BRIDGES
BRF-F-18-5(28)--2P-17

IOWA
DEPARTMENT OF TRANSPORTATION
Highway Division

DESIGN NO. 1082 — ~~OVER~~ IDEAL CREEK — STA. 371+94.5
CERRO GORDO COUNTY
SECTION 12 — ~~T-96N~~ — R-20W — MASON TWP.

DESIGN FOR WIDENING
42'-6 x ~~30'~~ CONCRETE DECK GIRDER BRIDGE
TO
42'-6 x 68' ~~PRE~~STRESSED DOUBLE-TEE BEAM BRIDGE

SITUATION PLAN

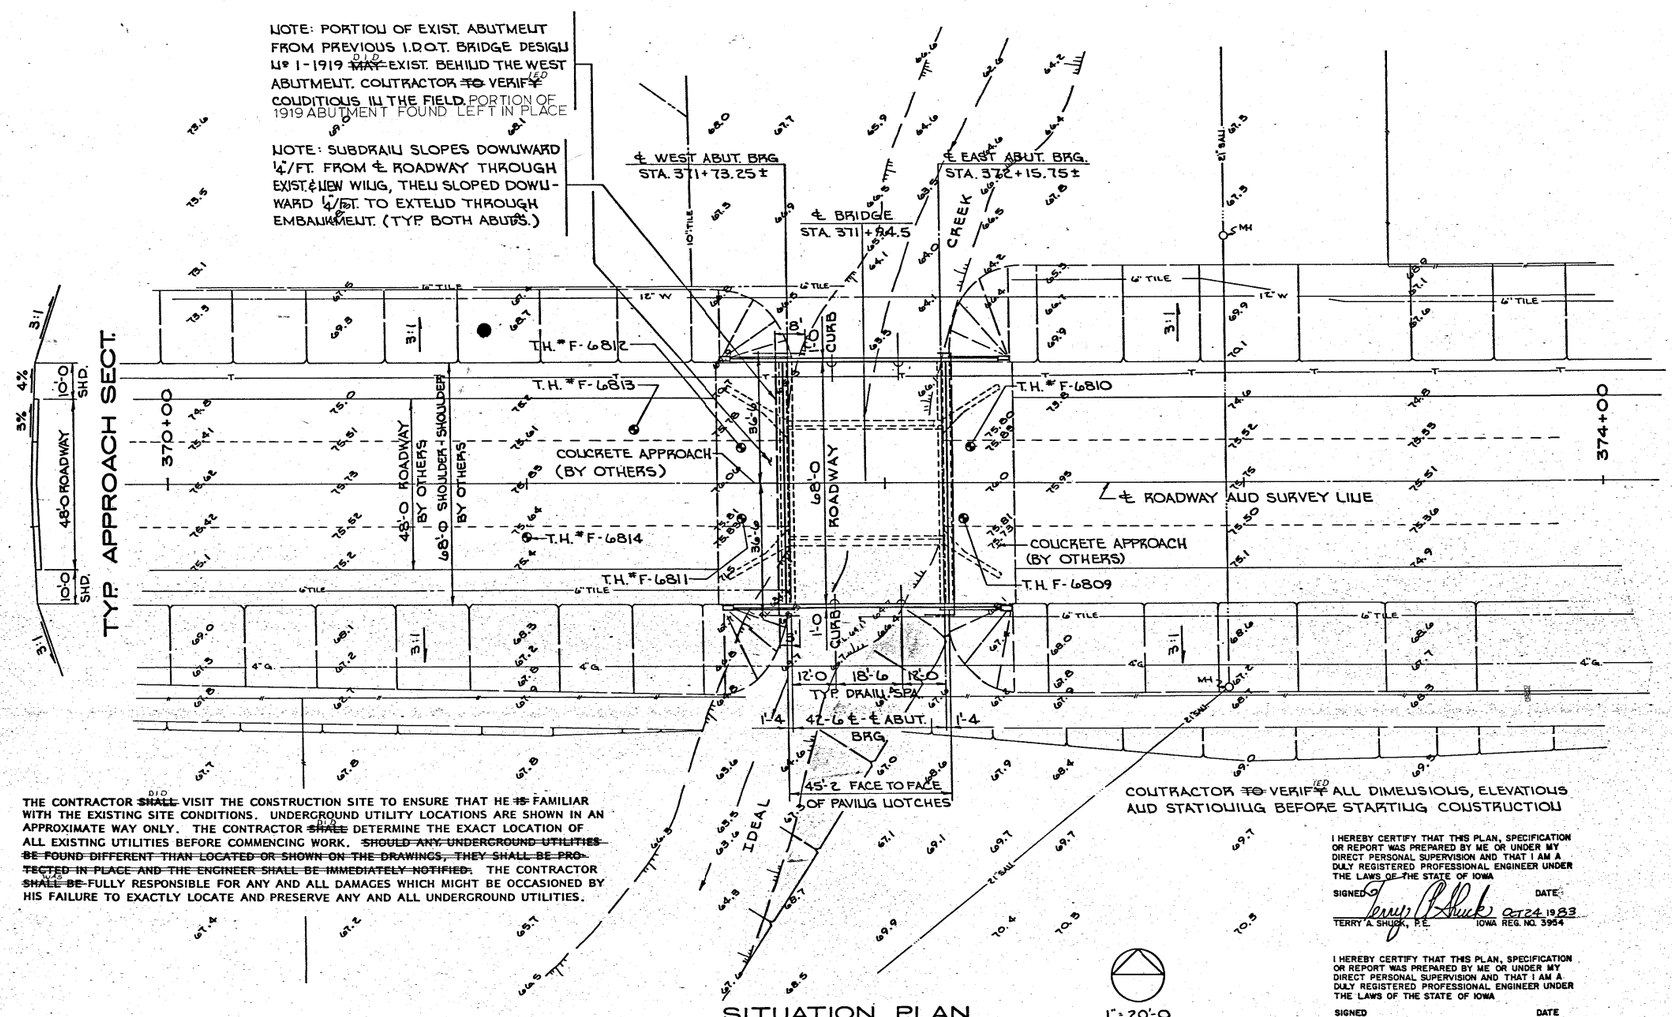
NOTE: PORTION OF EXIST. ABUTMENT FROM PREVIOUS I.D.O.T. BRIDGE DESIGN No 1-1919 ~~MAY~~ DID EXIST. BEHIND THE WEST ABUTMENT. CONTRACTOR ~~TO~~ SHALL VERIFY CONDITIONS IN THE FIELD. PORTION OF 1919 ABUTMENT FOUND LEFT IN PLACE

PLAN - STAGES I & II

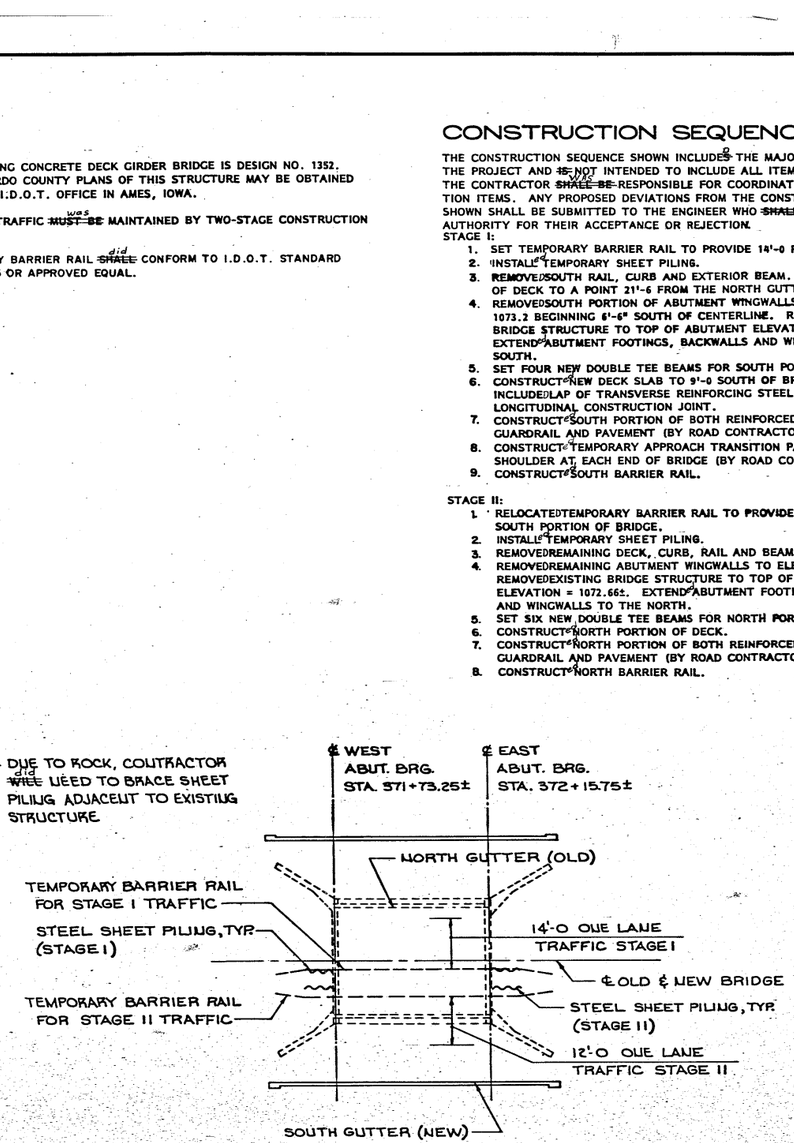
NOTE: DUE TO ROCK, CONTRACTOR ~~WILL~~ did NEED TO BRACE SHEET PILING ADJACENT TO EXISTING STRUCTURE

EAST ABUTMENT

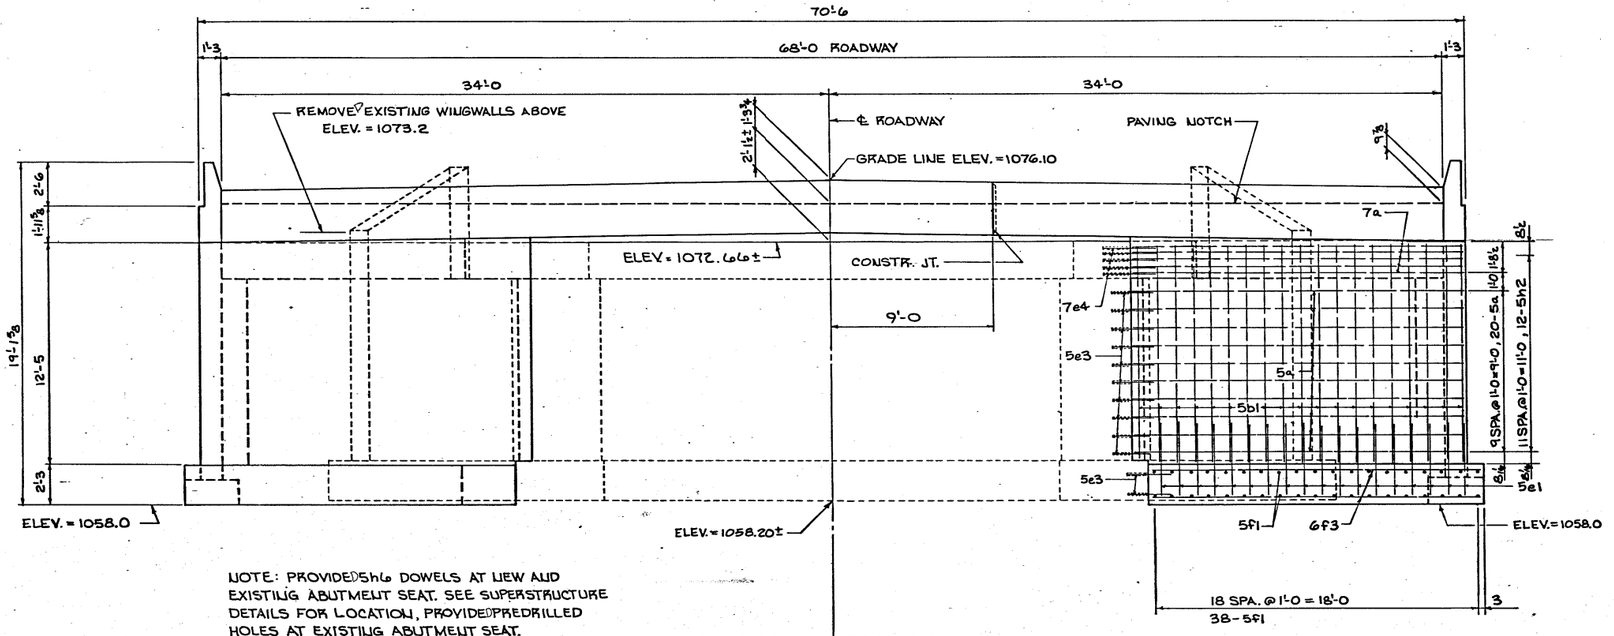
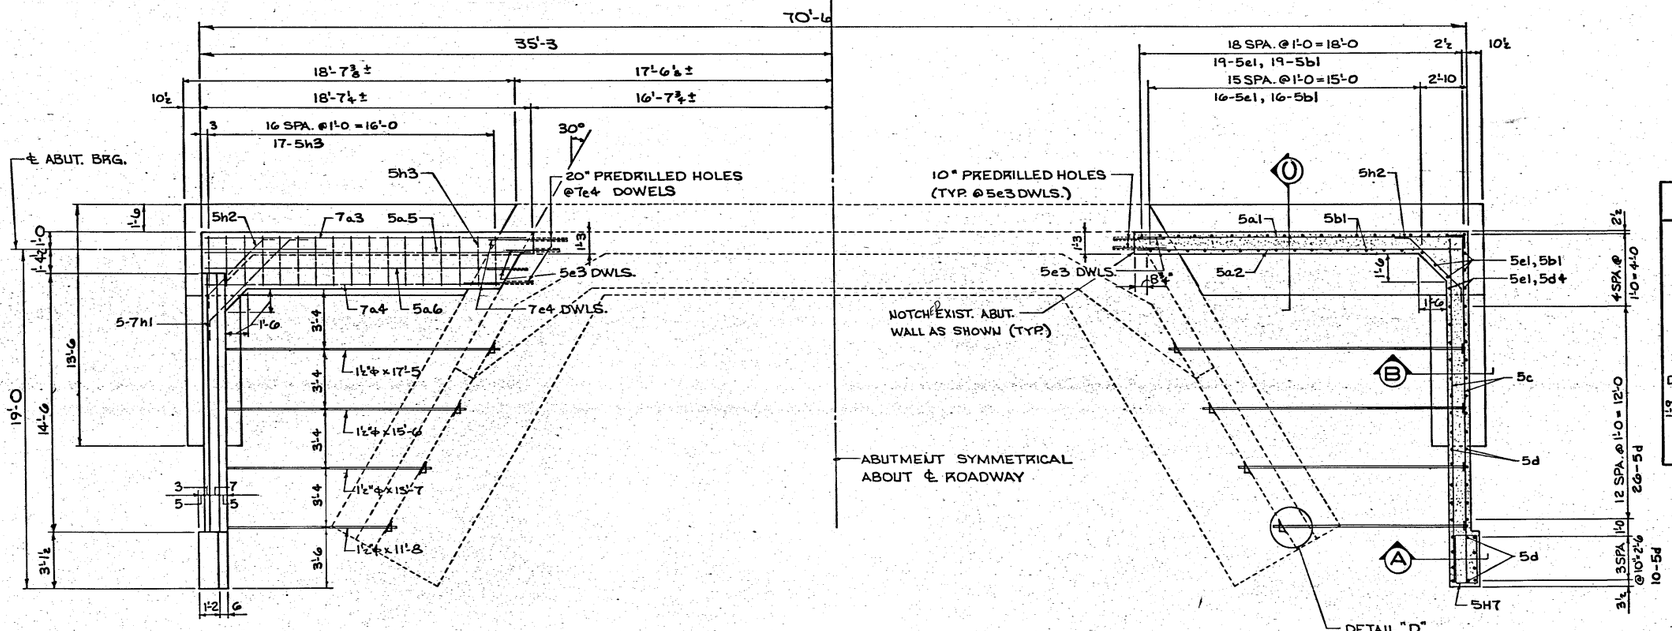
BENCH MARK No 11: ~~FOUND I.H.C. BM. IN NE. WING OF CONCRETE DECK GIRDER BR. 15' LT. ELEV. = 1076.78~~
Brass Plug on SE. Br End Post Sta. 372+32-35' Lt Elev. 1078.40

WEST ABUTMENT

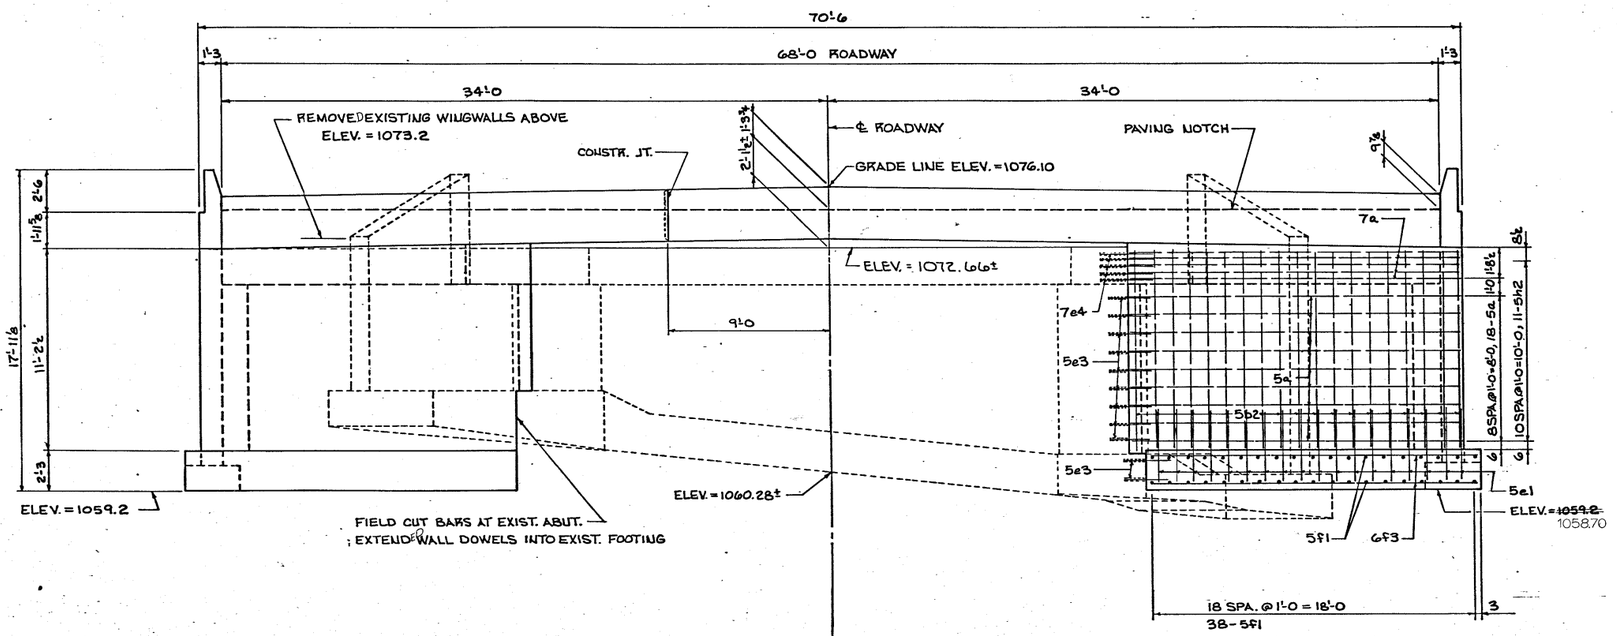
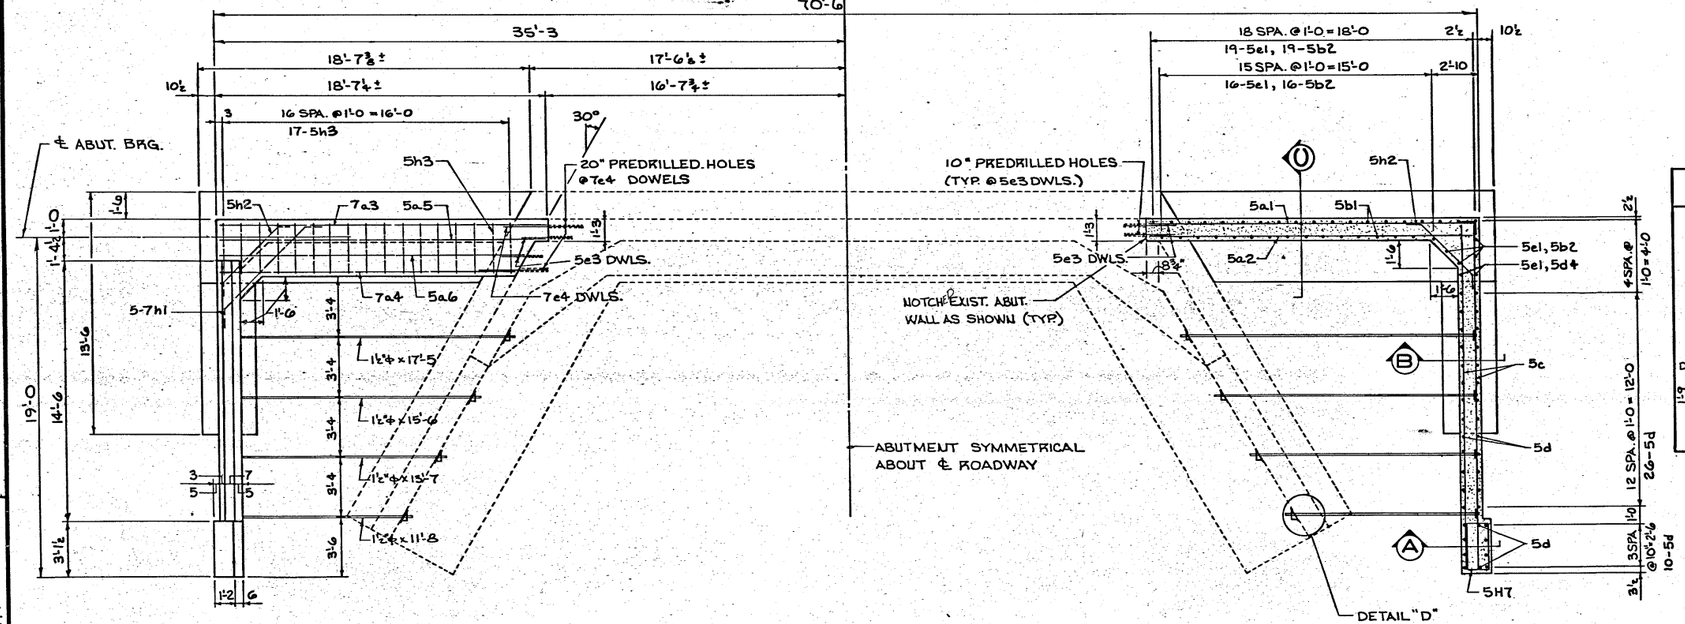
BENCH MARK № 11: ~~FOUND I.H.C. BM. IN NE. WING OF CONCRETE DECK GIRDER BR. 15' LT. ELEV. = 1076.78~~
Brass Plug on SE. Br. End Post Sta. 372+32 – 35 Lt. Elev. 1078.40

TOP OF ABUTMENT WALL DETAILS

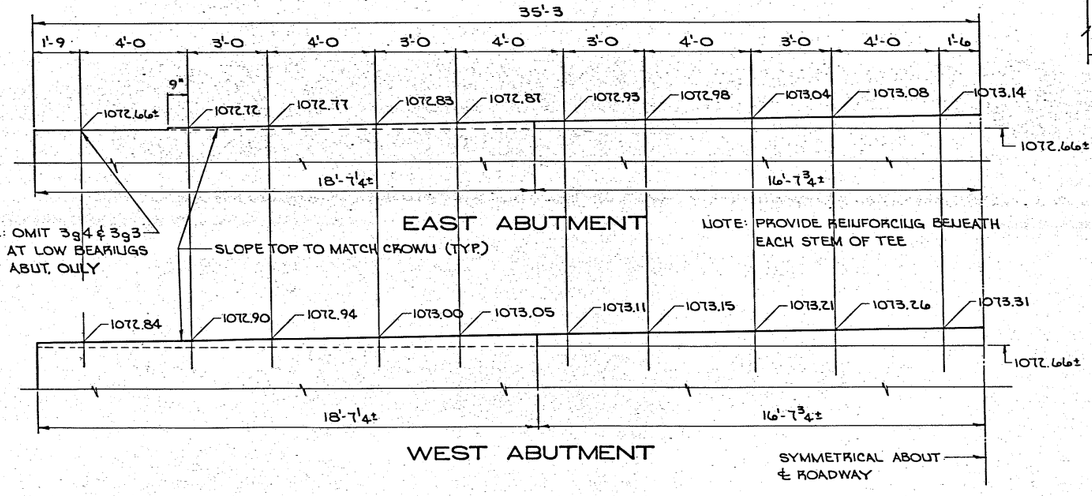
BACKFILL DETAIL PLACED AS SHOWN ABOVE TO COMPLY WITH DESIGN CHANGE **

~~** ALL BACKFILL BEHIND THE ABUTMENT AND BETWEEN EXISTING WINGWALLS IS TO BE GRANULAR BACKFILL. THE REMAINDER OF THE ABUTMENT EXCAVATION IS TO BE BACKFILLED WITH SUITABLE MATERIAL.~~

~~** BACKFILL BETWEEN EXISTING WINGWALLS AND NEW WINGWALLS TO BE GRANULAR BACKFILL FULL HEIGHT.~~

PLACE D BACKFILL AND FILL MATERIALS EVENLY ADJACENT TO ABUTMENT WINGWALLS. CARRY ~~ON~~ MATERIAL UNIFORMLY AROUND STRUCTURE TO APPROXIMATELY SAME ELEVATION IN EACH LIFT UNTIL FINISH GRADE ~~IS~~ WAS ACHIEVED.

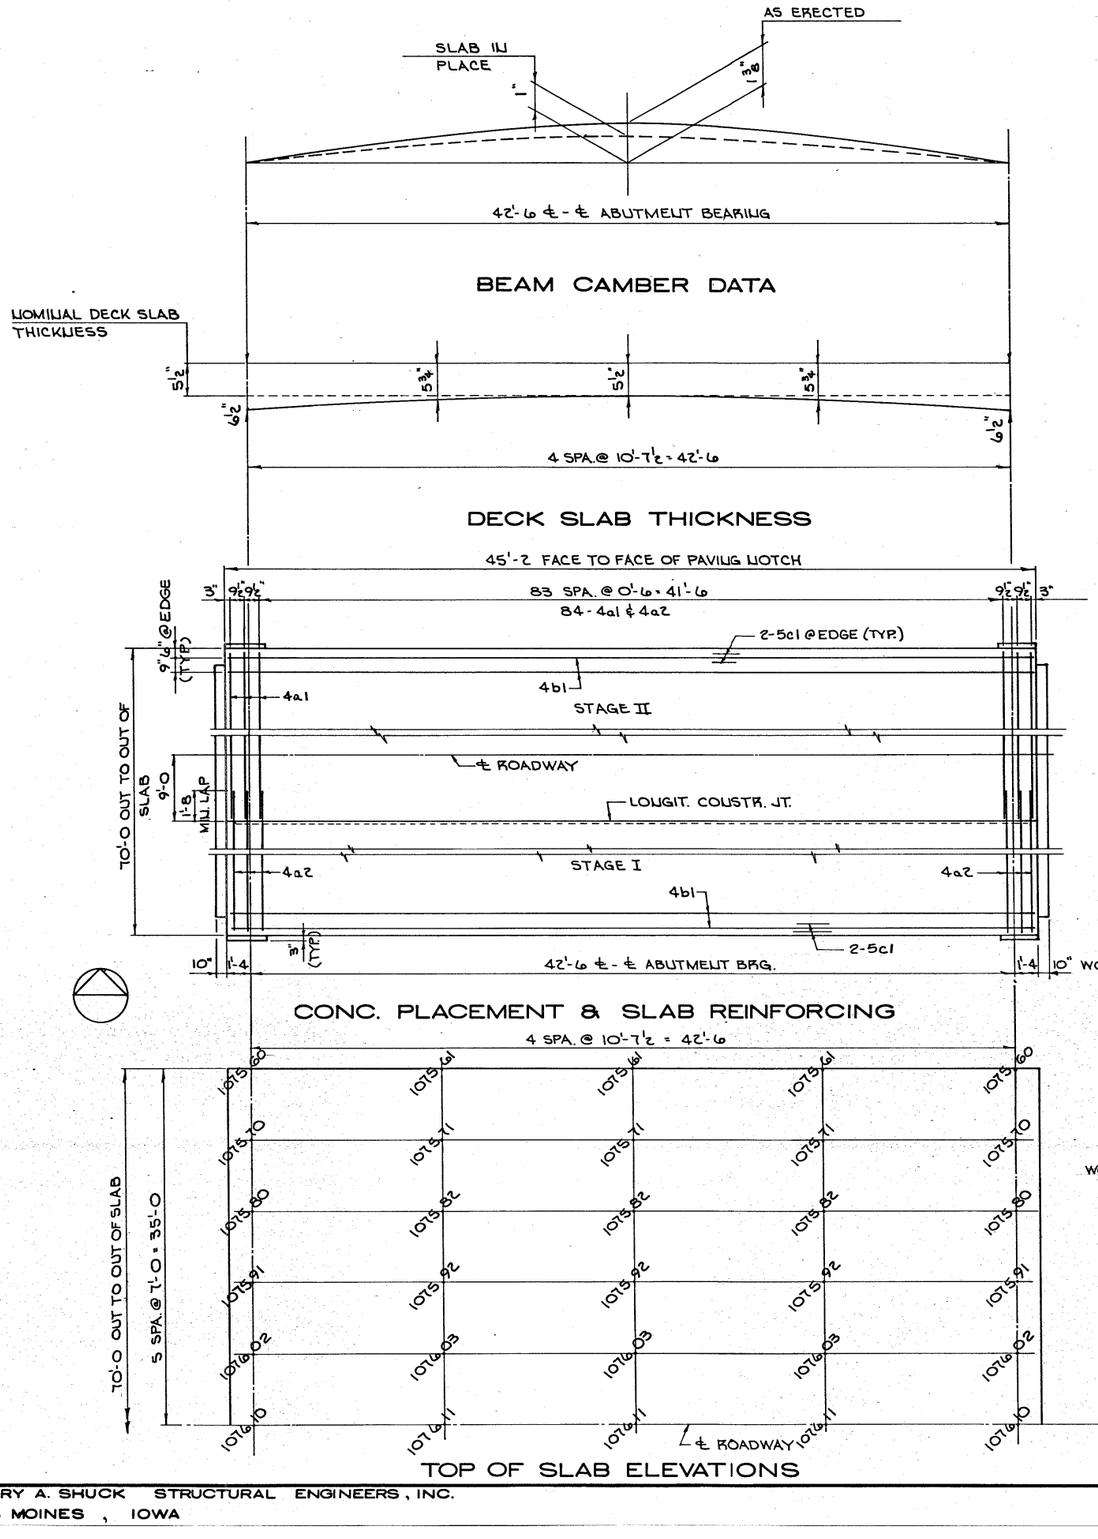
Bench Mark No. 11: Brass Plug on S.E. Br. End Post Sta. 372+32 - 35' Lt. Elev. 1078.40

BENCH MARK NO 11: FOUND I.H.C. BM. IN NE. WING OF CONCRETE DECK GIRDER BRIDGE 15' LT ELEV. = 1076.78
